**Project:** Lincoln Public Schools - Belmont Elementary School – Indoor Air Quality Improvements  
3425 North 14th Street, Lincoln, NE 68521

**Project No.:** Engineers Project No.: 2016-136

**ADDENDUM #1**

SHEET  
**E1.1B**

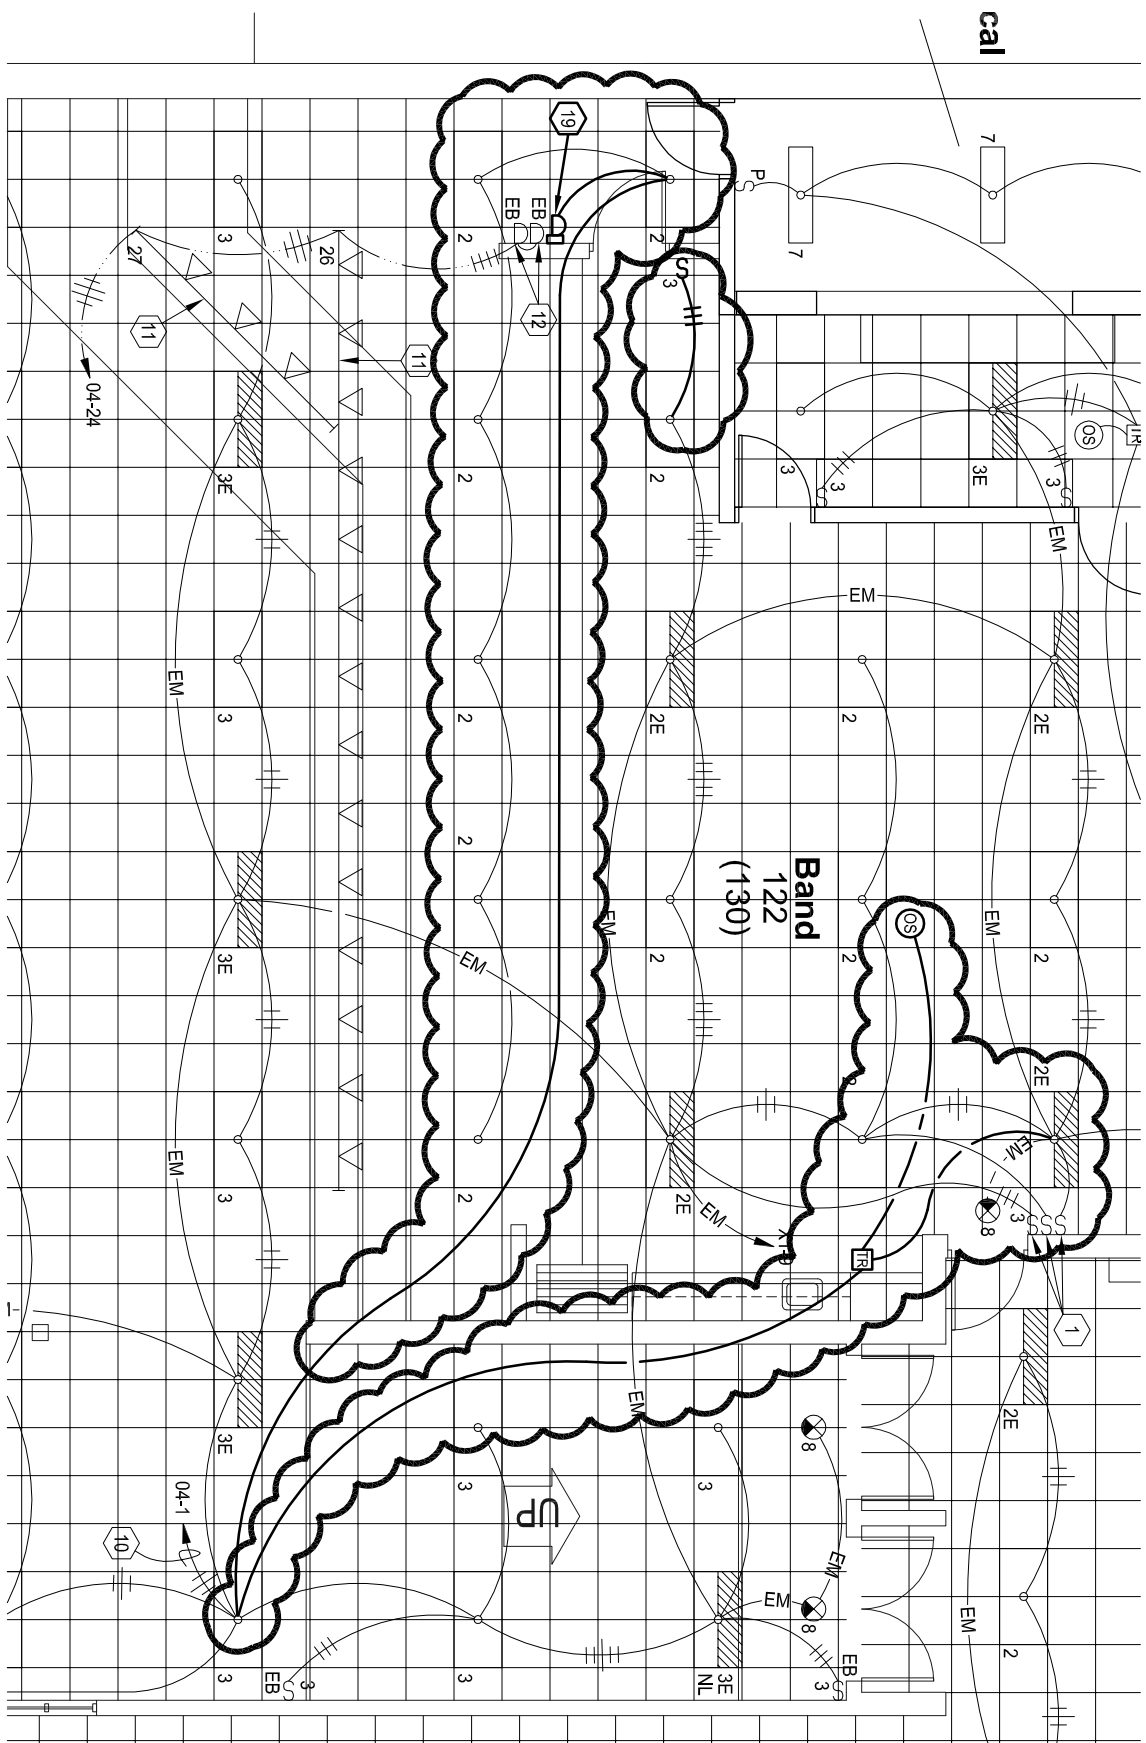
- B. Sheet E1.1B FIRST FLOOR PLAN – AREA B – ELECTRICAL DEMOLITION, (not reissued)
  - 1. See enclosed drawing Sheet E1.1B, Attachment #1, dated 3.9.2017 for removal of old cat5 data.

ADD #1
SHEET
<b>E2.1A</b>
ATTACHMENT NO.
<b>1</b>
03/09/2017

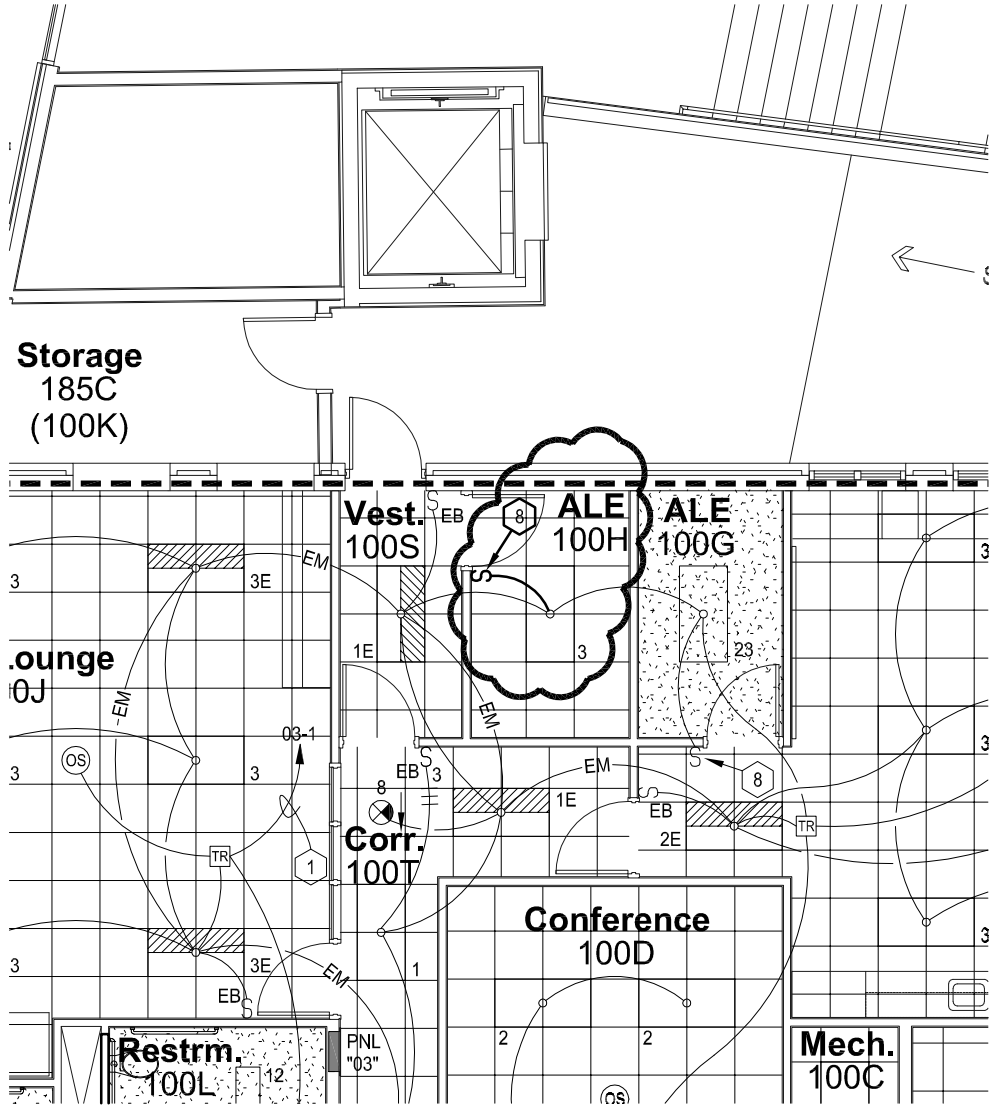
- C. Sheet E2.1A FIRST FLOOR PLAN – AREA A – LIGHTING, (not reissued)
  - 1. Junction box for the light switch in Mech. 183M is an existing box (EB).
  - 2. See enclosed drawing Sheet E2.1A, Attachment #1, dated 3.9.2017 for lighting changes.

BELMONT ELEMENTARY  
 IAQ - GROUND FLOOR  
 PLAN - AREA B - ELECTRICAL

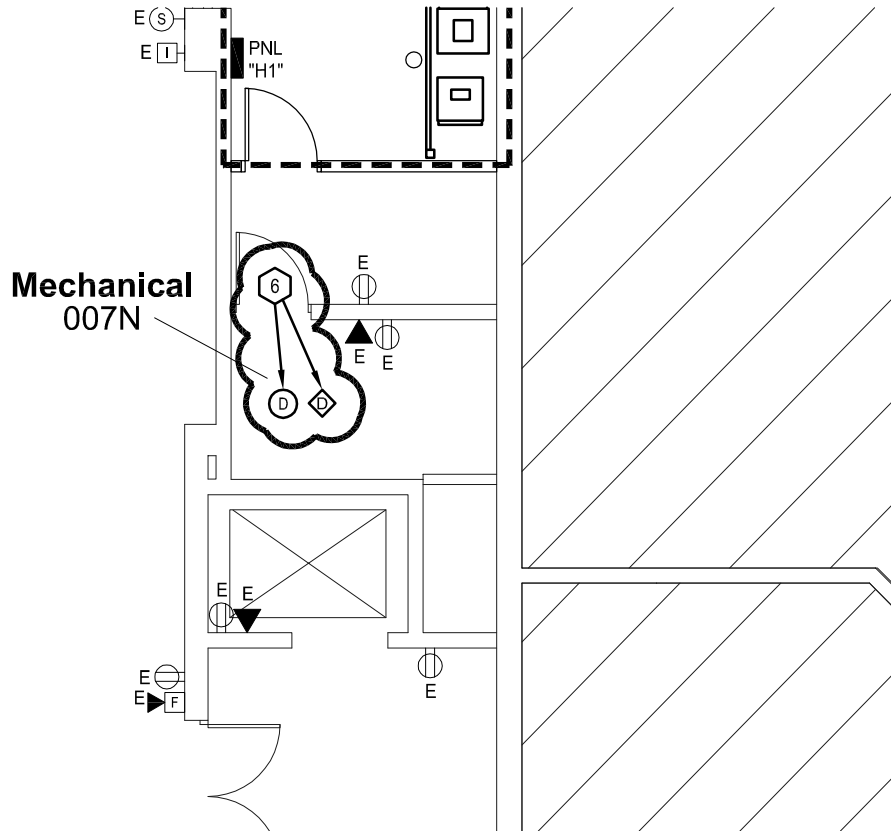
- F. Sheet E3.0B GROUND FLOOR PLAN – AREA B – ELECTRICAL, (not reissued)
  - 1. See enclosed drawing Sheet E3.0B, Attachment #1, dated 3.9.2017 for added fire alarm devices.

6. NEW FIRE ALARM DEVICE.

ADD #1
SHEET
<b>E3.1A</b>
ATTACHMENT NO.
1
03/09/2017

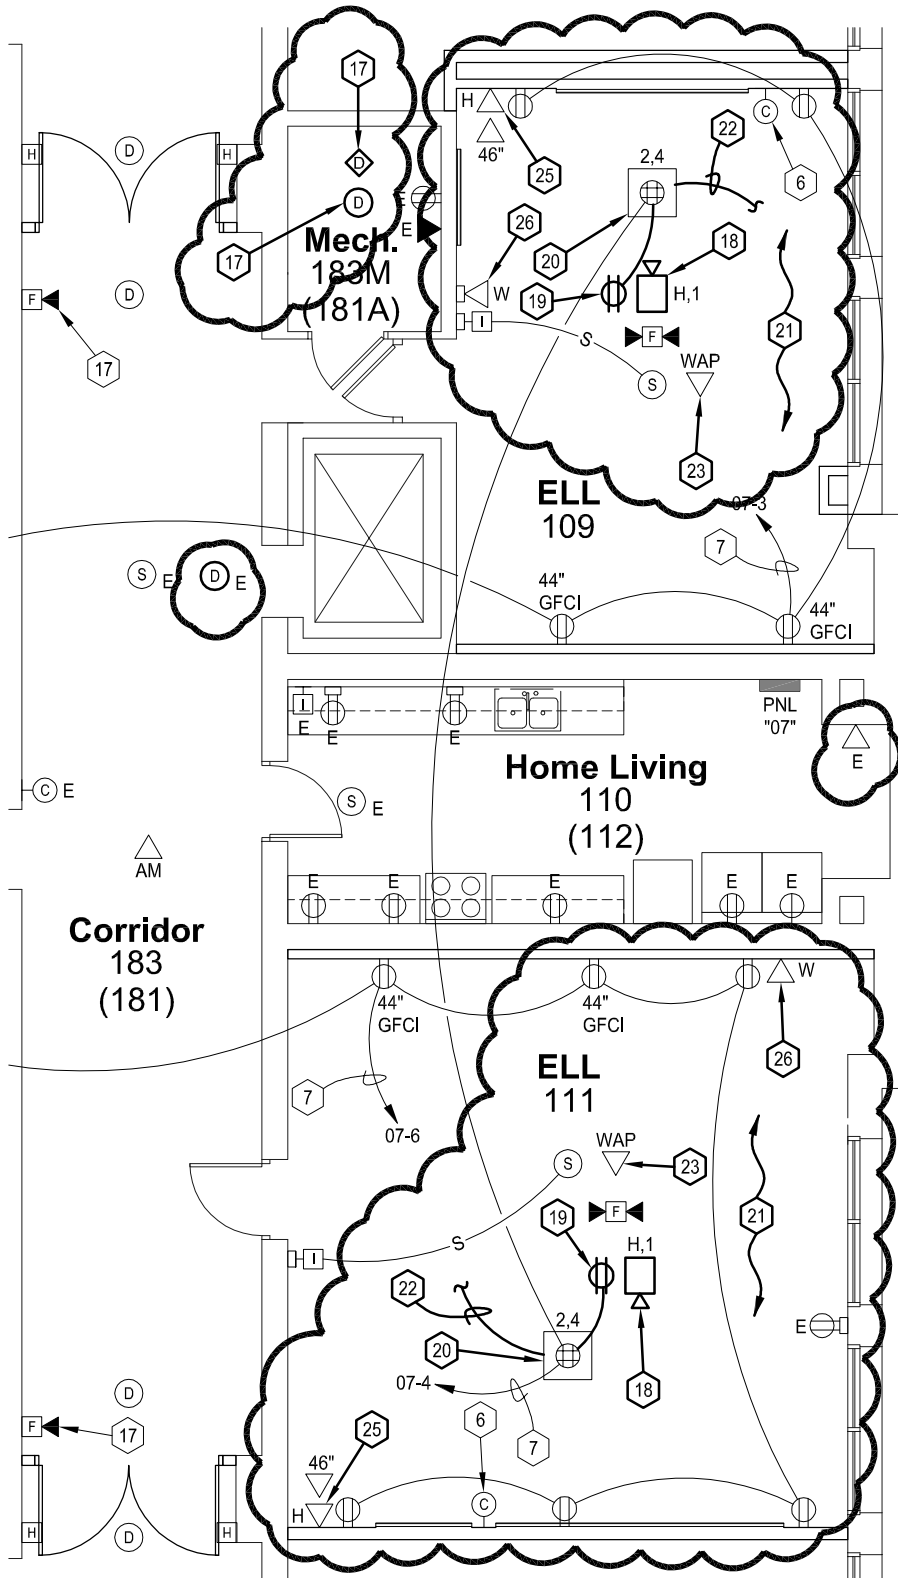
- G. Sheet E3.1A FIRST FLOOR PLAN – AREA A – ELECTRICAL, (not reissued)
  - 1. See enclosed drawing Sheet E3.1A, Attachment #1, dated 3.9.2017 for added notes.
